United States Department of the Interior
NATIONAL PARK SERVICE

Thank you for the opportunity to comment on the "Environmental Information Document Arsenic Facility Installation, Montezuma Rimrock Water Company, LLC."

Paul Christensen, Hydrologist
 NPS—Washington Office Water Resources Division
 Comments for EID

From an analysis of the EID by John Ward, R.G. (Independent Groundwater Consultant Contracted by NPS)

2.2 REGIONAL DECLINE IN GROUND-WATER LEVELS

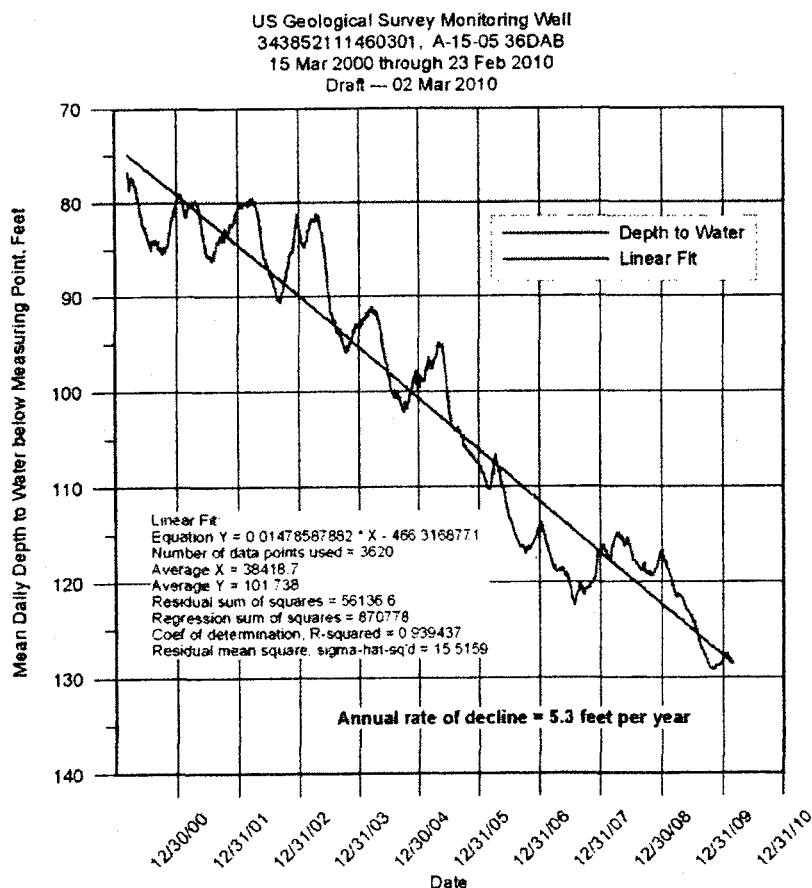
pp. 7-8. The groundwater levels of the upper unit of the regional aquifer is declining about 5.3 feet per year in the area of the AFI project. See graph below.

Water levels from this US Geological Survey monitoring well were not included in Figure 4 of the report. This well is located about 1,250 feet northeast of MRWC Well No. 4, about 850 feet southeast of MRWC Well No. 1, and about 2,400 feet south-southeast of MRWC wells No. 2 and No 3.

pp. 8-9. 2.3 MONTEZUMA WELL NATIONAL MONUMENT AND BEAVER CREEK

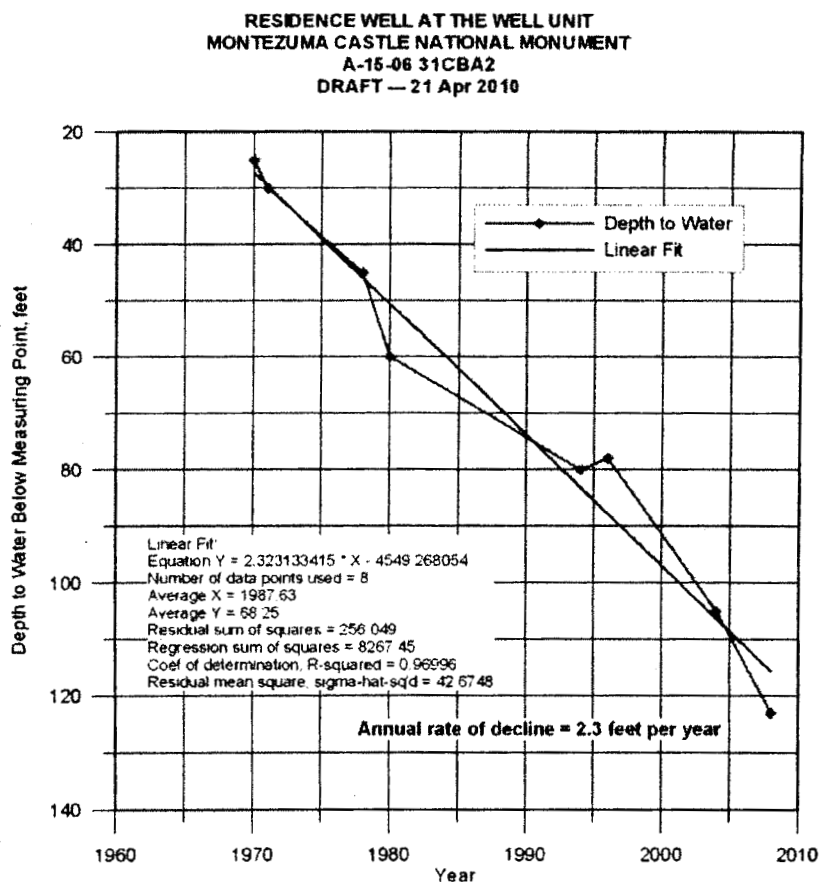
P. 8, 1st paragraph. At the Residence Well within the Well unit of Montezuma Castle National Monument, water levels have been declining about 2.3 feet per year. See graph below.

The Residence Well is located about 2,800 feet east-northeast of Well No. 4. This well provides water to the Well Unit.
